**Amendment to the
First Amended and Restated
ERCOT Standard Generation
Interconnection Agreement**

CED Upton County Solar 2, LLC

April 19, 2017

**AMENDMENT TO THE
FIRST AMENDED AND RESTATED
ERCOT STANDARD GENERATION
INTERCONNECTION AGREEMENT**

Exhibit "C1" **Point of Interconnection Details** **Second Amendment**

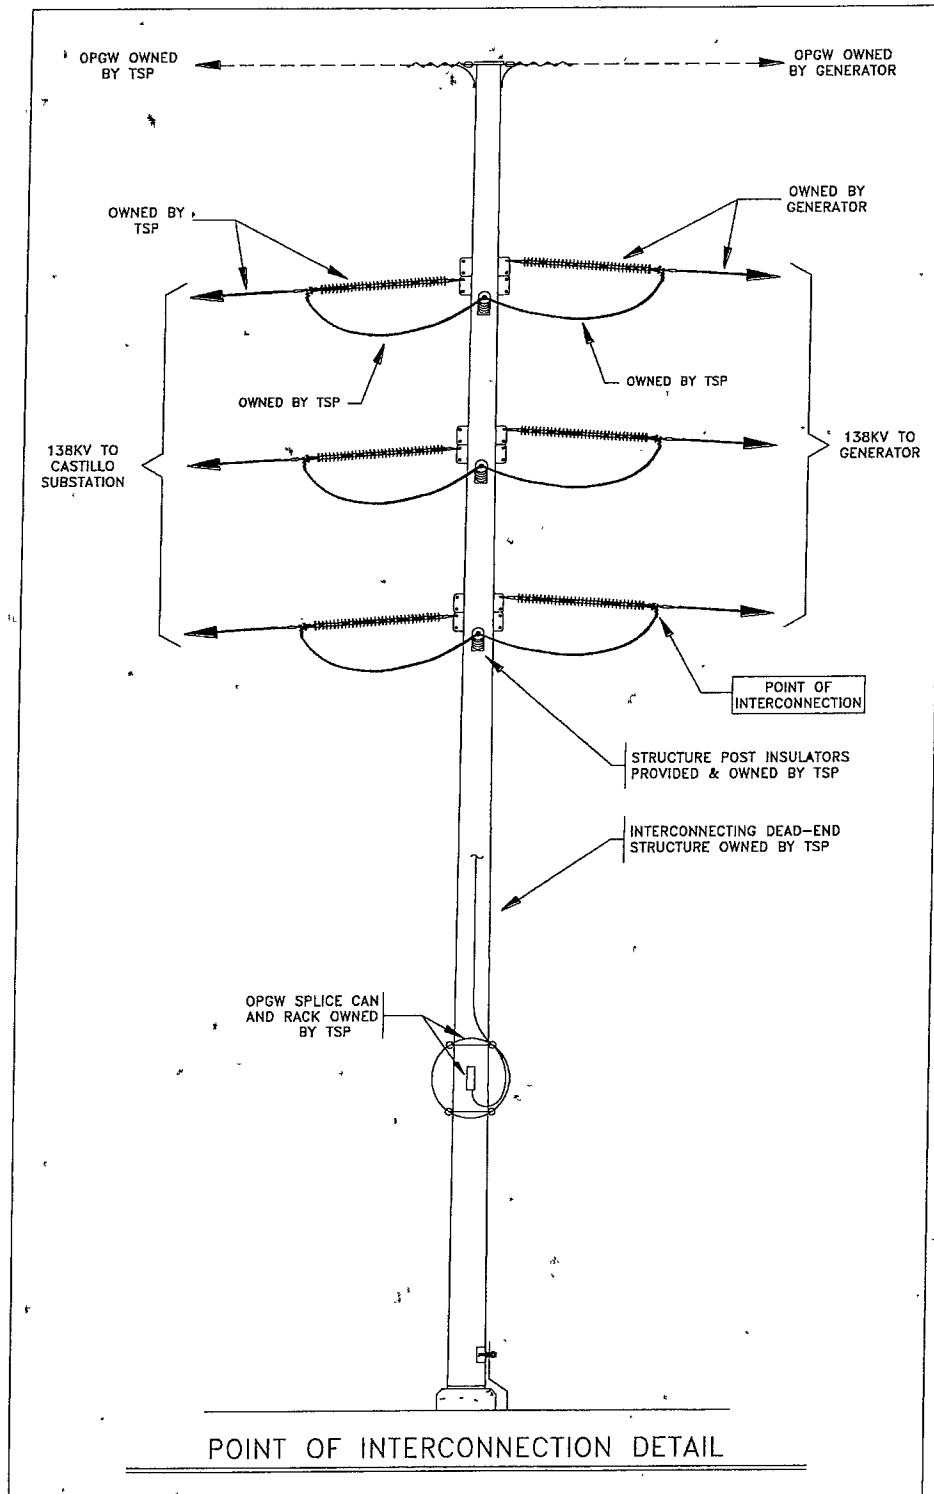
WHEREAS, Generator notified TSP of a change in the proposed location for the Generator's interconnection substation which changes the actual location of the TSP's point of interconnection line structure;

WHEREAS, TSP requested that the OPGW between the Parties also terminate at the new location of the point of interconnection structure;

1. Name: Castle Gap owned by CED Upton County Solar 2, LLC
2. Point of Interconnection location: The Point of Interconnection will be at the end of the TSP's new radial 138-kV line located in Upton County, TX, at the approximate location shown in Exhibit "C3". The TSP's new radial 138-kV line will extend from the Point of Interconnection to the LCRA TSC Castillo Substation ("TSP Substation"). The Point of Interconnection, shown on Exhibit "C1" and Exhibit "C2" shall be the physical point where the TSP's 138-kV transmission facilities are connected to the GIF. This point is more specifically defined as being located at the 4-hole pad terminals on the dead-end assembly where the Generator's 138-kV line connects to TSP's interconnecting dead-end structure on the TSP's new radial line.

Exhibit "C2" One Line Diagram **TSP Interconnection Facilities, Generation Interconnection** **Facilities and The Plant** **Second Amendment**

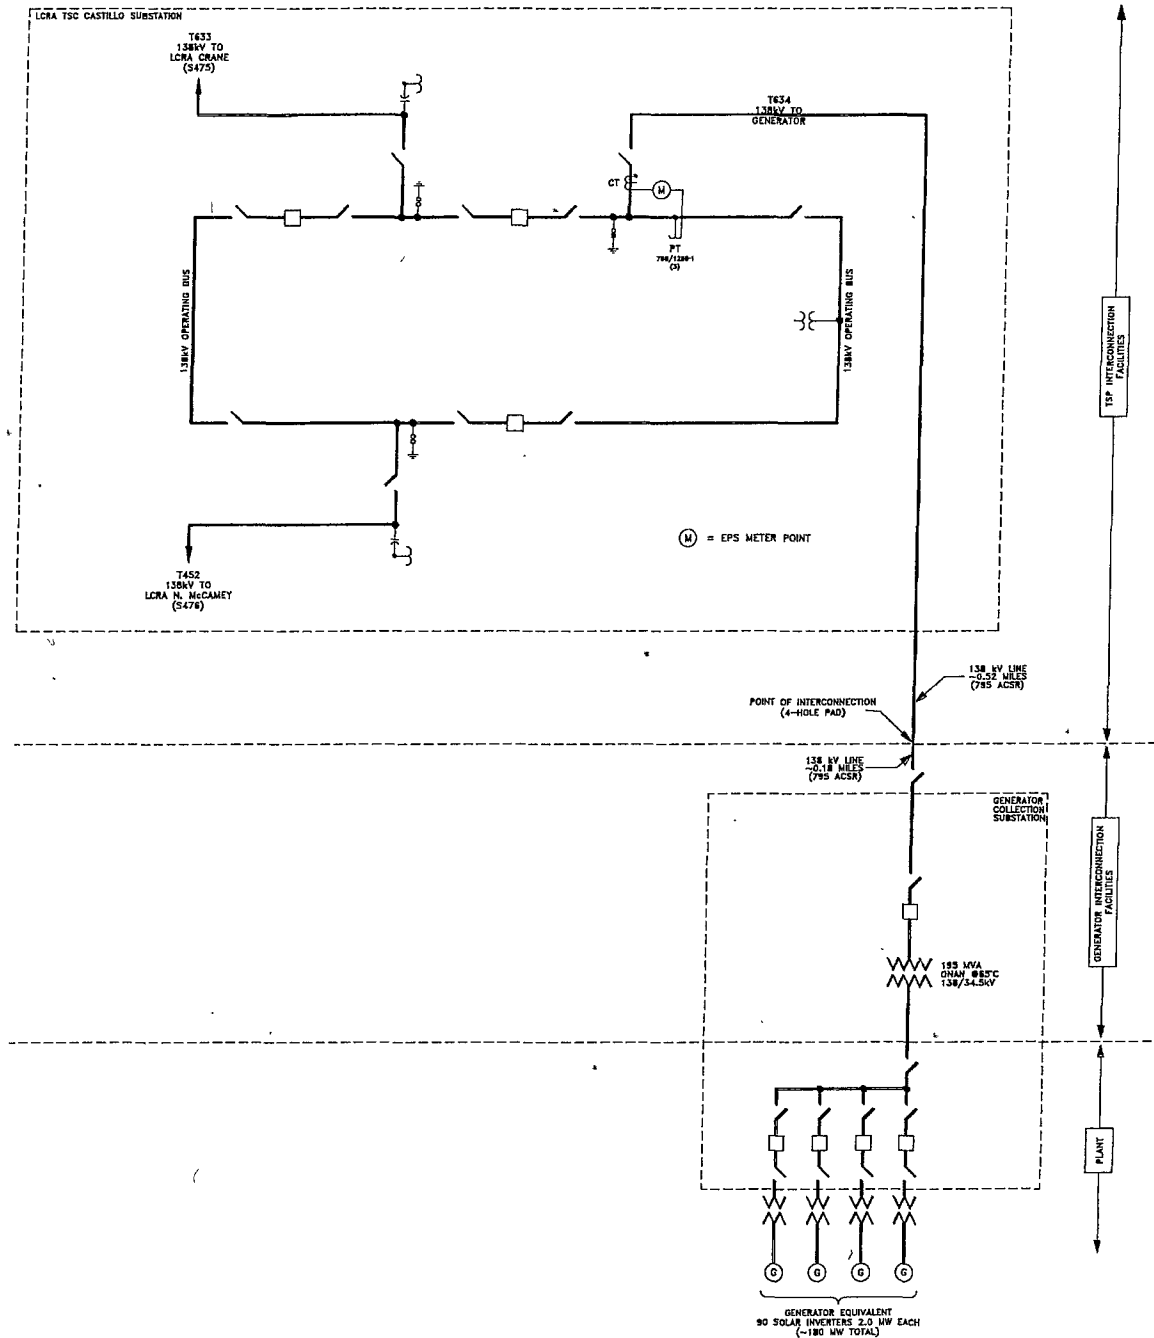
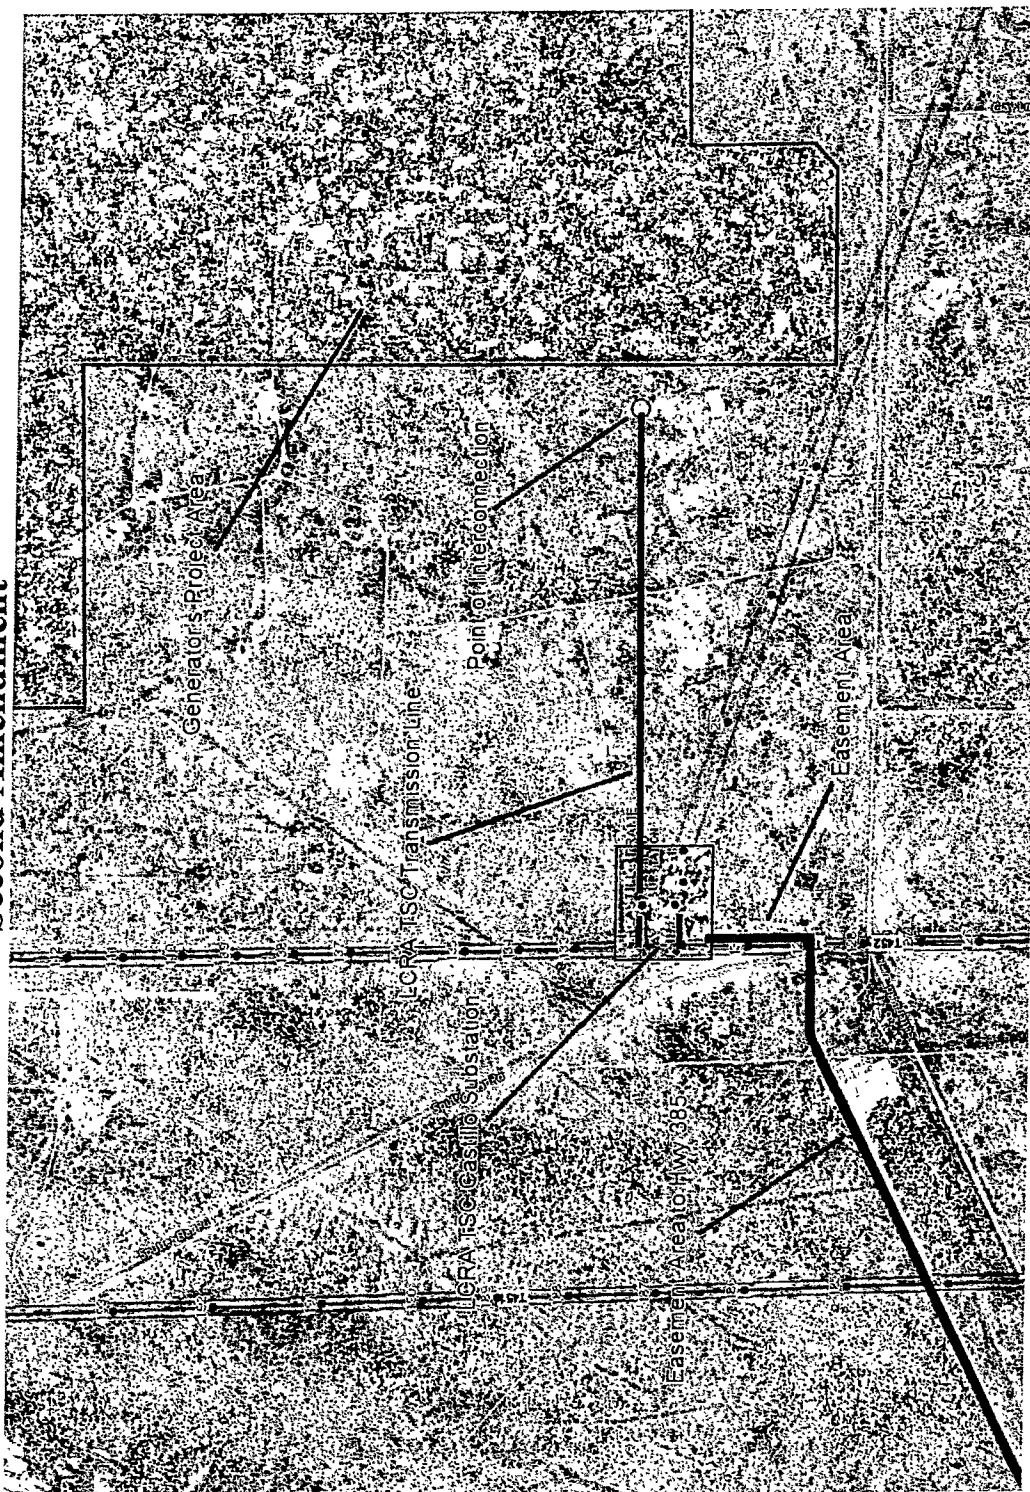
WHEREAS, the Generator decided to use KACO inverters at the CED Upton County Solar 2 project;

WHEREAS, Generator will not be split into phases; and

5. Type of Generating Unit: 90 KACO BP 2200 TL3 solar inverters, rated at 2.0 MW (2.2 MVA each.)
6. Metering and Telemetry Equipment:
 - A). ERCOT settlement metering shall be provided by TSP and located at the TSP Substation. 138-kV extended range, metering current transformers will be used to accurately read the generation energy and power delivered to the grid and the auxiliary energy and power consumed through the Point of Interconnection, collectively for the entire Plant. 138-kV metering accuracy voltage transformers shall also be installed by the TSP for the ERCOT settlement metering. An ERCOT settlement metering panel containing primary and backup EPS meters shall be furnished by the TSP. TSP shall employ line loss compensation in the TSP owned EPS meters to reflect the actual metered consumption adjusted for line losses to the Point of Interconnection.
